ADEQUACY OF STATION ELECTRIC DISTRIBUTION SYSTEM  
VOLTAGES, DRESDEN STATION - UNIT NOS. 2 AND 3,  
DOCKET NOS. 50-237 AND 50-249, TAC NOS. 12765  
AND 12807

Report No. EGG-EA-5322

ADEQUACY OF STATION ELECTRIC DISTRIBUTION SYSTEM VOLTAGES

DRESDEN STATION - UNIT NOS. 2 AND 3

DRESDEN STATION  
UNIT ONE LINE DIAGRAM  
UNITS 2, 3  
FIGURE 1

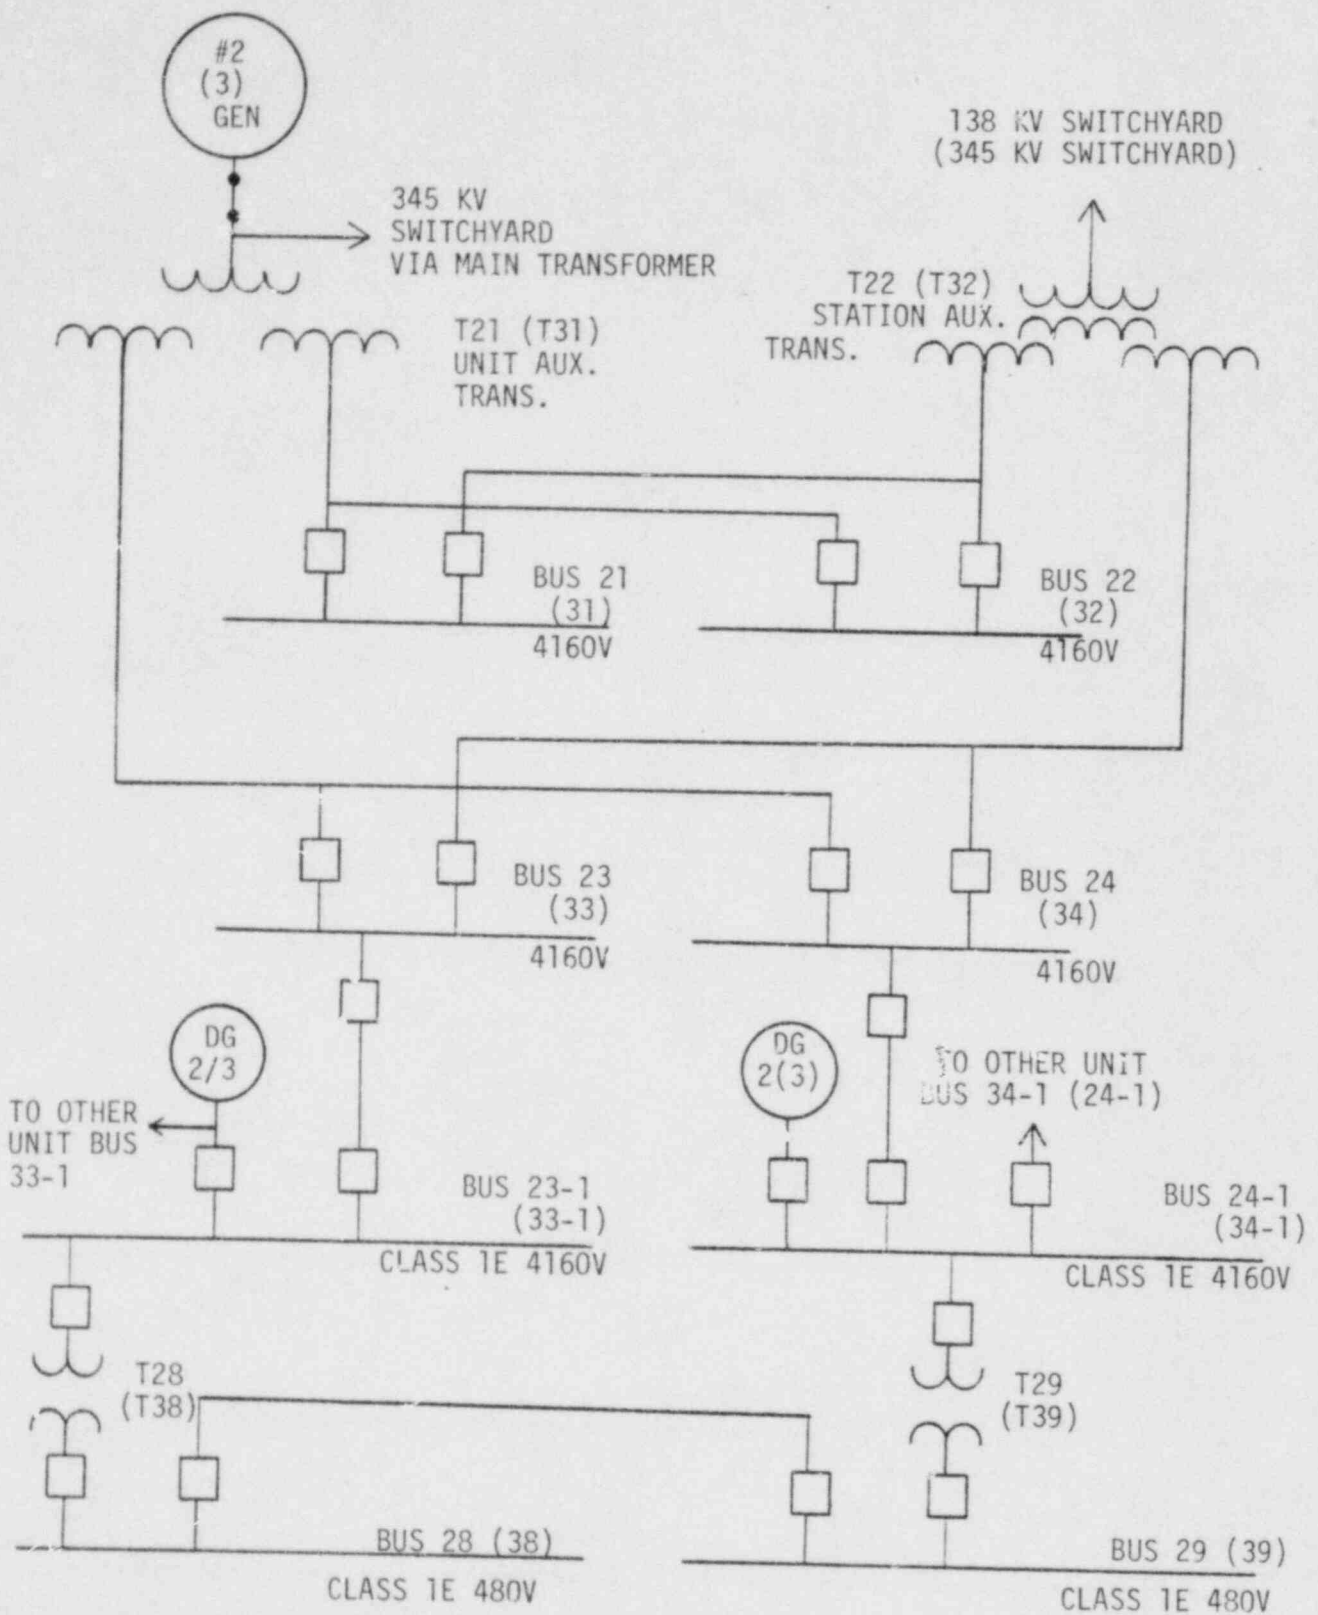
The enclosures of references 2 and 4 discuss the onsite distribution system. Figure 1, page 3 of this report, is a simplified sketch of the class 1E electric distribution system taken from the Sargent & Lundy report of reference 2.

The Unit 2 class 1E 4160V buses 23-1 and 24-1 are normally supplied power from auxiliary buses 23 and 24, respectively. These buses are supplied power during emergency conditions by a 133/4.16kV station auxiliary transformer (SAT)<sup>a</sup> (Unit 3 uses a 345/4.16kV SAT). Bus 24-1 can be energized from the other unit<sup>3</sup> by a manual connection to bus 34-1 of Unit 3.<sup>b</sup> The unit technical specifications credit this as the second source of power required by GDC 17. This inter-tie can also be used to power bus 34-1 from bus 24-1 serving as the second source of offsite power for Unit 3. The Unit 2 distribution system is identified in the FSAR as being typical of Unit 3, except for bus and transformer numbers.

Each 4160V class 1E bus supplies power for one 480V class 1E bus via independent 4160/480V transformers. 120V vital buses are normally supplied power by motor-flywheel-generator sets<sup>4</sup>. These will soon be replaced by battery-powered inverters.
